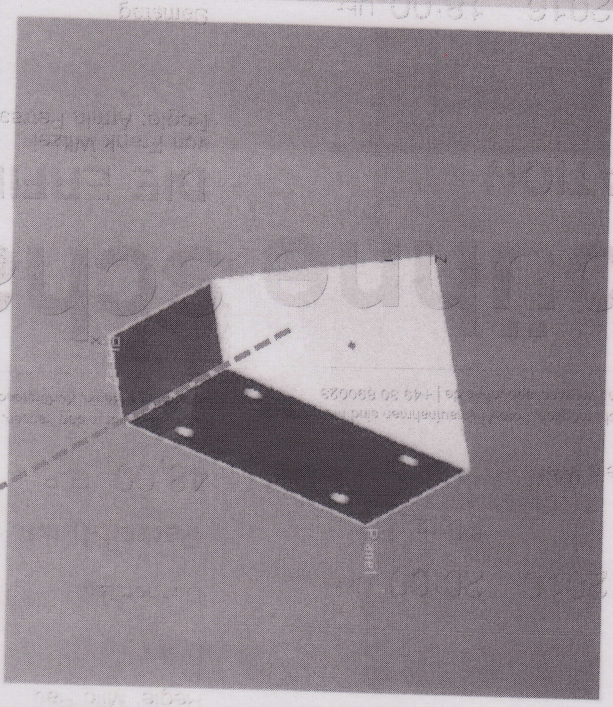
4X 1.25-12 UN-3B
 FULL THD ∇ 2.8-3.2
 MINOR DIA $\text{\textcircled{D}}$ D-B/C

I've never seen this call out before. Both D and B are planes.

Intersection line
 of 2 planes
 is datum D-B

Angle > 90°
